Moreland City Council changes shown maroon/light blue with explanatory comments by Karen Bayly and Kate Shearer

MORELAND PLANNING SCHEME

SCHEDULE 12 TO CLAUSE 43.04 DEVELOPMENT PLAN OVERLAY

GRONN PLACE, BRUNSWICK WEST

- Interface Treatment B (Kitchener Street) – 4.5m street setback up to 3 storeys and an additional 3m setback above 3 storeys (as shown in the diagram below);**

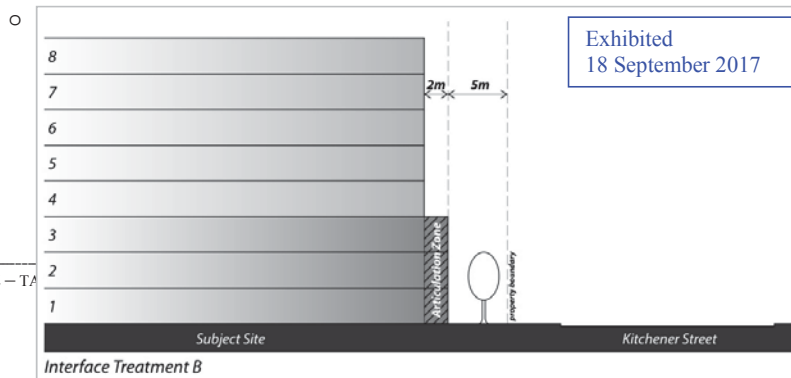
Comment [KS42]: As per councils submission section 6, Further information is required in the DPO schedule to ensure detail in relation to building facades, interfaces and treatments. Ground level interfaces are not shown on the *Design Framework* and have not been addressed in the DPO Schedule. Similarly, entrances to the site and podium treatments have not been indicated in the Development Concept Plan in the schedule. Further detail of the interfaces around buildings is needed in the schedule, not merely diagrams showing suggested heights.

Comment [KB43]: Without prejudice. Council submits that the maximum building height should not exceed four storeys. Council advises the Advisory Committee that if 6 or 8 storeys are contemplated for the site that Councils considers these to be appropriate minimum setbacks.

Comment [KS44]: These setbacks are from B17 of Clause 55.04 calculated at 3m per storey (Clause 58 specifies a 2.7m min floor to ceiling height) plus 4m for ground floor as required by this DPO

Comment [KB45]: INSERT CROSS SECTION DIAGRAMS TO SHOW SETBACKS FROM RESIDENTIAL INTERFACES

Comment [LM(52): Responding to KS42 &44 and KB43, 45-47, KB49-51. DHHS proposes the concept plan map and additional cross-sections issued on 9 October 2017 and relies on our evidence and submissions.

- Interface Treatment B (Kitchener Street – northern portion) – 5m street setback with articulation zone corridor plus a 2m articulation zone up to 3 storeys and an additional 2m setback above 3 storeys (as shown in the diagram below);**

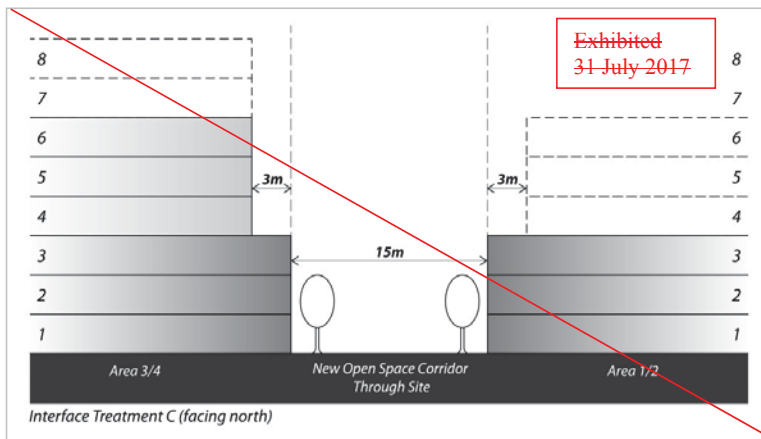
Comment [KB46]: Edit this diagram DHHS Urban Design evidence paragraph 64 reduce height of the precinct at the northern end of Kitchener Street to 6 storeys

~~Interface Treatment C (New Open Space Circulation Corridor Through Site) – 3m setback for portions of buildings above 3 storeys 18m wide corridor plus a 2m articulation zone (as shown in the diagram below); and~~

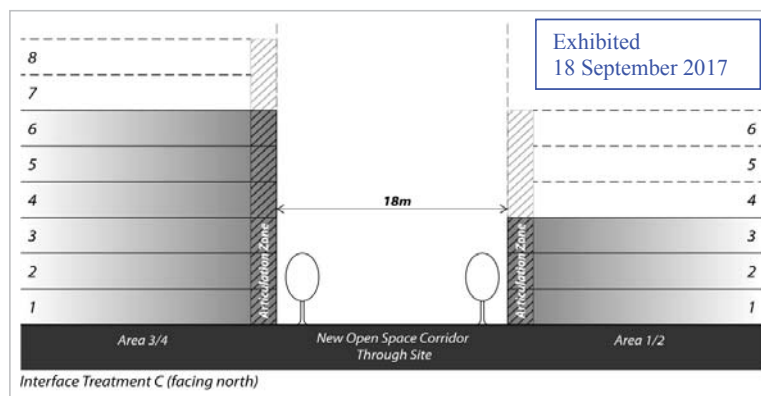
Comment [KB47]: This will not be open space. It will be driveways, footpath and cycle path. On the Walker Street Concept Plan the equivalent is labelled 'Internal connections' Refer to Sections in Design Framework DHHS Urban Design evidence paragraph 37 describes this space as an internal street incorporating footpaths, kerbside parking and street trees to 'read' as 'normal' streets contributing top the integration of the estate with its surrounds

Comment [LM(48): Responding to KB47. Reject. The open space corridor will contain road for part. It will also include cycle and pedestrian paths, which are a feature of open space areas, and will also include tree planting, grass areas, a community garden and other communal uses as appropriate.

5.0 Development Concept Plan

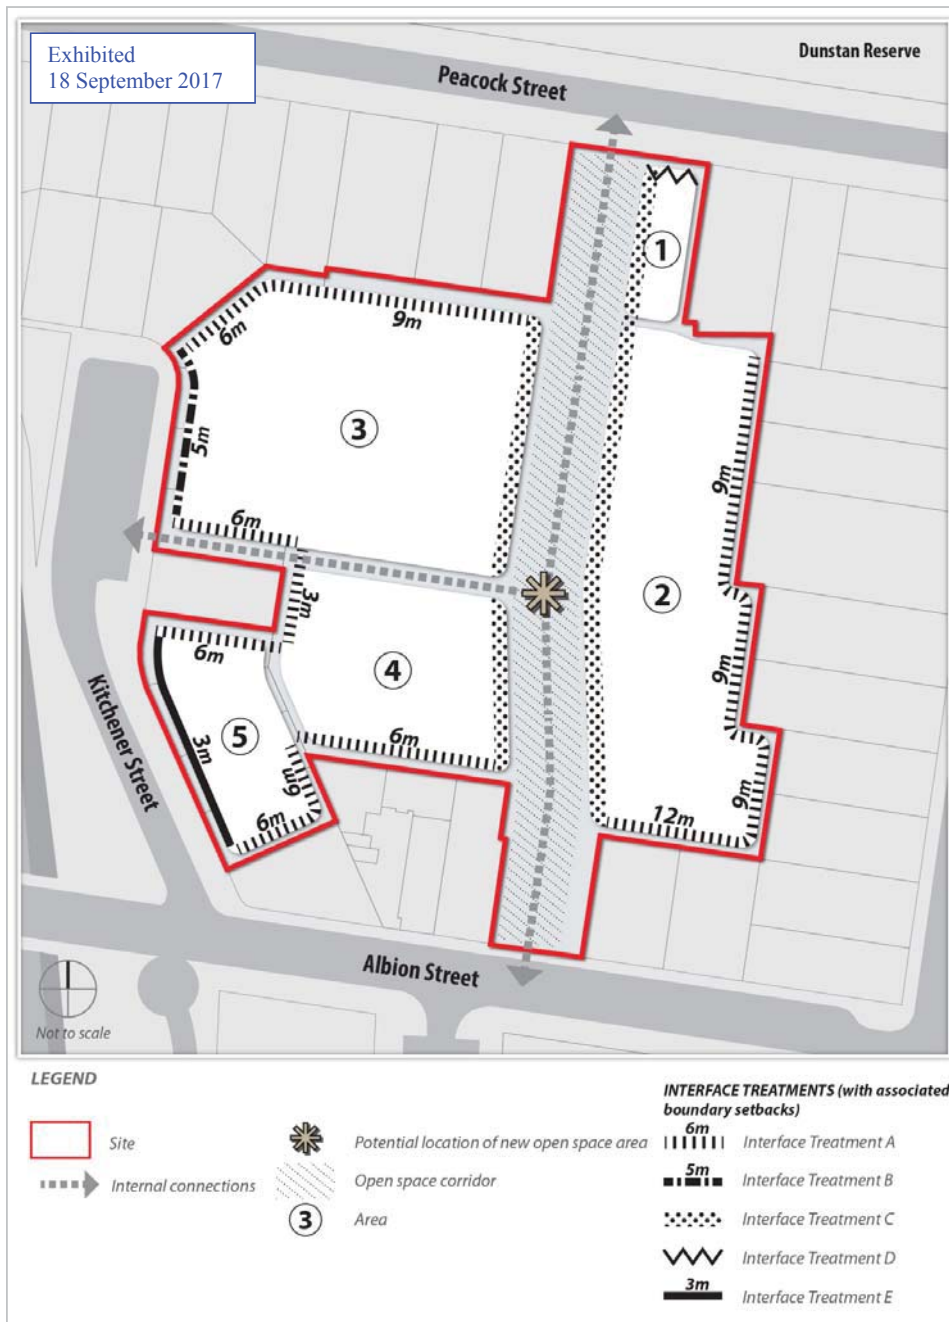
Comment [KS37]: As per section 6 of Councils submission, the Development Concept Plan should be revised to incorporate more detailed moveme ... [15]

Comment [KB92]: Because the Development Plan MUST be generally in accordance with the Development Concept Plan, want as much detail as possible in this plan

Comment [LM(38): Responding to KS37. Part Accept comment by clearly defining pedestrian and vehicular linkages in Development Concept Plan, how ... [16]

Comment [LM93]: Responding to track changes and Council Development Concept Plan. DHHS favours the Development Concept Plan included in the DPO schedule circulated by DHHS on 09 October 2017. The Council's version is too detailed and prescriptive and inappropriate for a DPO schedule.
